CPRE Sussex
Brownings Farm
Blackboys
East Sussex TN22 5HG
Telephone 01825 890975
info@cpresussex.org.uk
www.cpresussex.org.uk

CPRE Sussex representation Objecting to:

DC/25/1312

Land West of Ifield Charlwood Road Ifield West Sussex

Figure 12.3: Gatwick Airport 2040 Option 3 (Wide Spaced Mixed Mode) No EATs 2040 Leq 54-72 dB(A) Contours Daytime overlain on the Proposed Development’s built infrastructure parameters

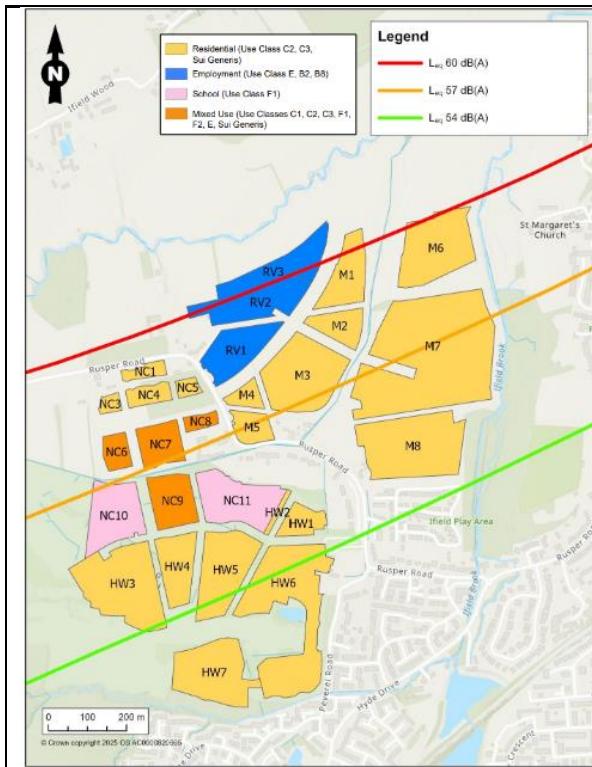
30.3 The daytime noise contours show that the greater part of the proposed scheme would be located between aircraft noise contours 60 and 57 and 57 and 60 dB(A) Leq,16hour.

35 Day time noise levels measured at positions LT1, LT2, LT 3 and LT4 are all greater than the noise contours shown on Figure 12.4. Likewise, the measured night-time noise levels.

35.1 Daytime noise levels measured at ST 2, 3, 4, 5, 6, 7 and 8 are greater than the noise contours shown on Figure 12.3

37. With the partial exception of ST 1 the measured Day and Night-time noise levels appear to be greater than the noise contours shown on Figures 12.3 and 12.4.

38. There is a substantial mismatch between the noise measurements obtained by the daytime and night-time surveys conducted in 2022, between c June and 7 July, and the noise contours shown on Figures 12.3 and 12.4 of the applicant's Environmental Statement Volume 1 Main Report: Noise and Vibration.

38.1 Further on-site measured aircraft noise surveys are therefore essential.

Figure 12.4: Gatwick Airport 2040 Option 3 (Wide Spaced Mixed Mode) No EATs 2040 Leq 54-72 dB(A) Contours Night-time overlain on the Proposed Development’s built infrastructure parameters

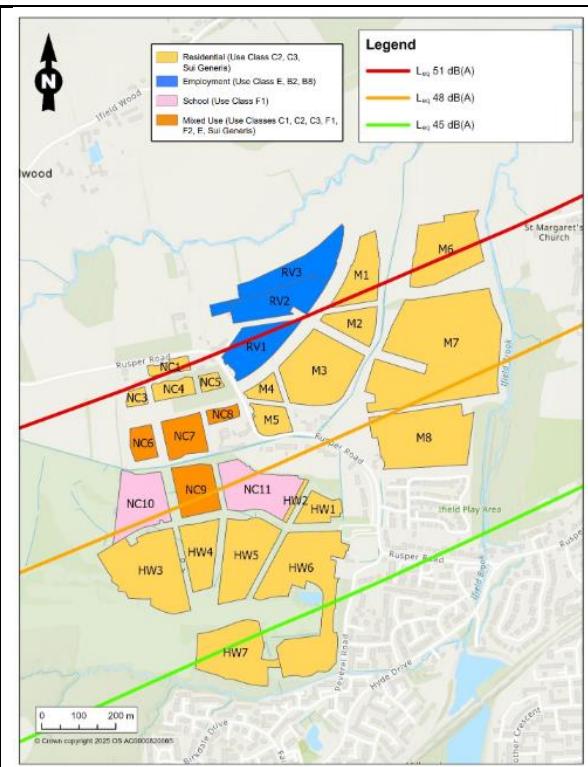
30.4 The night-time aircraft noise contours show that the greater part of the proposed scheme would be located between noise contours 51 and 48 and 48 and 45 dB(A) Leq,16hour.

36. Night-time noise levels measured at ST 2, 3, 5, 6, 7 and 8 appear to be greater than the noise contours shown on Figure 12.4.

36.1 The minimum night-time noise level, 52 dB, measured at ST 1 seems to correlate with the 51 dB contour.
